FRDM-K64F Board Errata

by: Freescale Semiconductor, Inc.

Document Number: FRDMK64F_ERRATA
Rev. 2.0
06/2014

Figure 1. Swapped I²C signals Pin18 and on J2

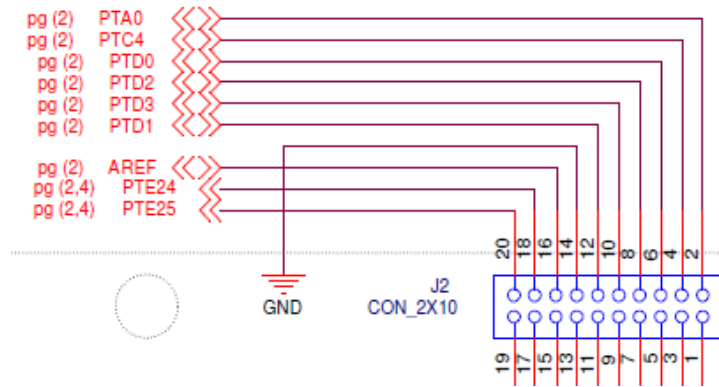
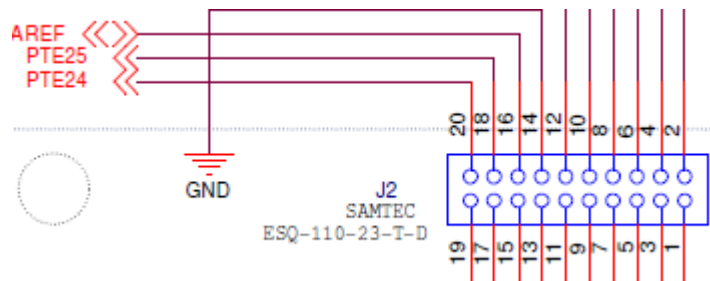
Description: Pin 18 (I²C0_SCL) and pin 20 (I²C0_SDA) of J2 I/O Header, and pin 10 (I²C_SCL) and pin 12 (I²C0_SDA) of J4 I/O Header are swapped. [Figure 1](#) and [Figure 2](#) show the incorrect signals.

1. Use jumper wires to connect between Arduino compatible shield signals to the FRDM board I/O header signals. Swap the jumper wires only on the I²C signals.
2. When pin 10 of J4 (PTC10) and pin 12 of J4 (PTC11) are not used on the shield, route pin 10 of J4 to pin 20 of J2 and pin 12 of J4 to pin 18 of J2. Configure PTE24 and PTE26 (pin 18 and pin 20 of J2) as GPIO, and use PTC10 and PTC11 (pin 10 and pin 12 of J4) as I²C signals.

Fix Plan: Fixed in FRDM-K64F board (700 Assembly Rev B, Schematic Rev D1).

Figure 5. Correct order of I²C signals on J2

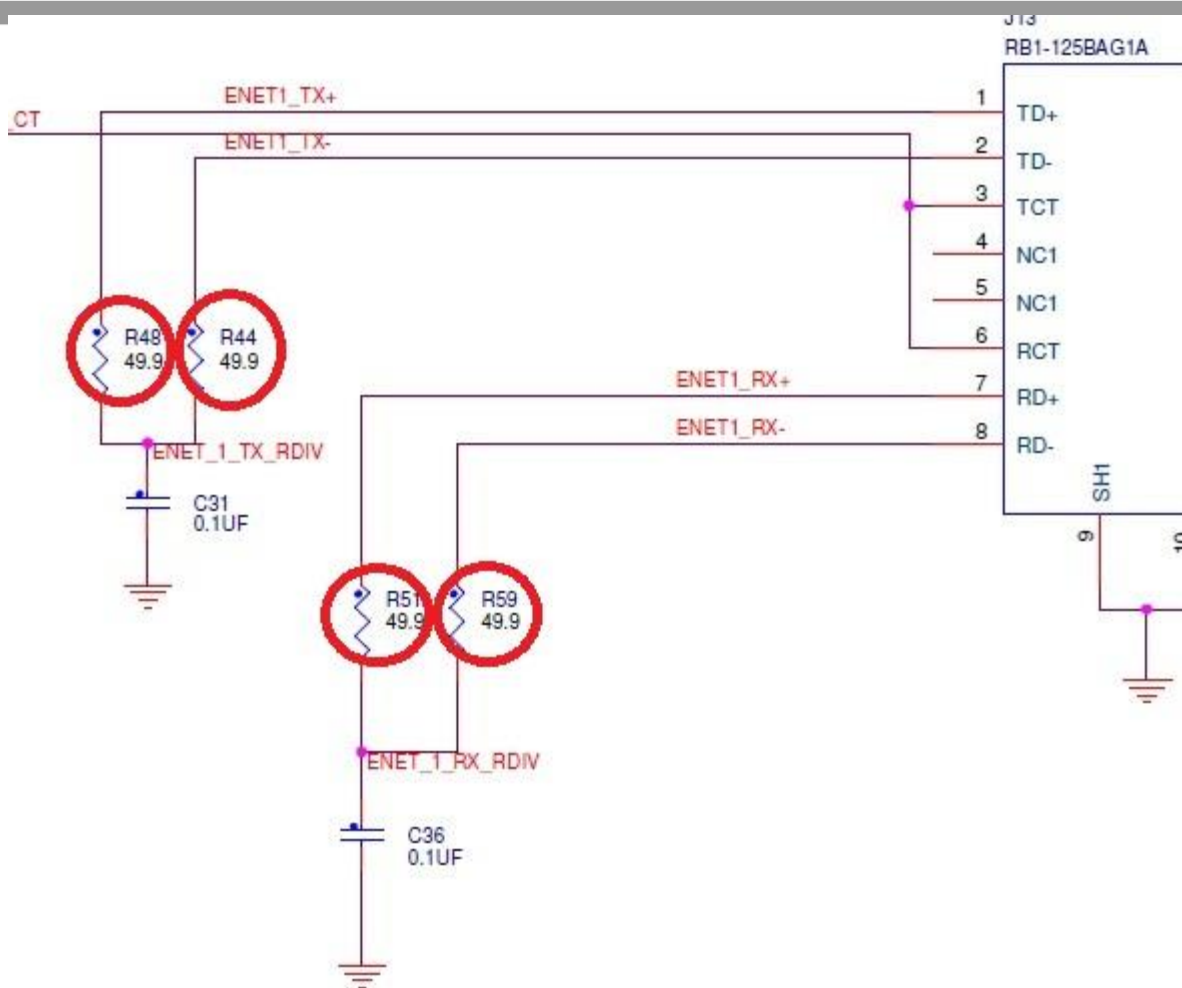
Description: When two FRDM-K64F boards are connected together with an Ethernet cable, the Ethernet PHY can't establish the link status, and will drop to a default state of 10Mbit and half duplex mode. This is caused by incorrect termination on the TD+ and RD+ signals, which reduces the link signal detection. This issue does not affect other connections such as PC host to FRDM-K64F, TWR-SER1/2 to FRDM-K64F, or network switch to FRDM-K64F when the cable length is less than 25 feet. This issue affects both Rev C and Rev D1 boards.

Workaround: Remove the four resistors R44, R48, R51, and R59 that connect to TD+, TD-, RD+ and RD- signals.
